Metro Vancouver's Cycling Advocates

May 24, 2011

Re: Low Level Road Project

Figure 1. West to East profile existing vs. proposed.

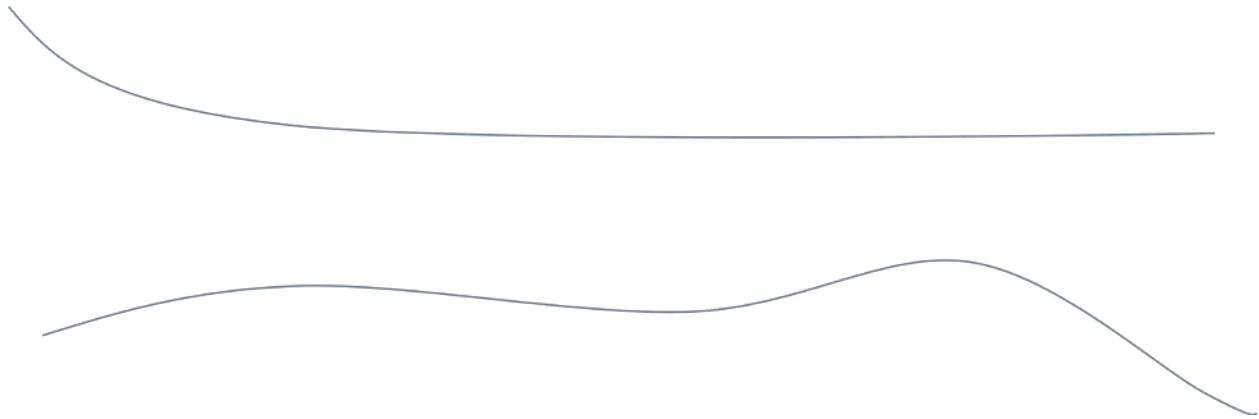
A review of drawings for the project leads us to believe that two new hills will be introduced where none existed. Currently, the Low Level Road is the only flat east-west connection in the area. On every other route (3rd Street, Keith Road or trails) cyclists must climb very steep hills. Figure 1. below shows a rough comparison of the profile for the existing and proposed Low- Level route moving from West to East.

In the drawings we have seen recently (May 17, 2011) the grades have been flattened significantly and the steepest grade would be around 6.4%. This is a definite improvement over the previously proposed 8%. However hills with a grade of 5% will serve as barriers to some cyclists and to people in non-motorized wheel chairs. We recommend grades of no steeper than 4%. To achieve this, the project would need to start further east.
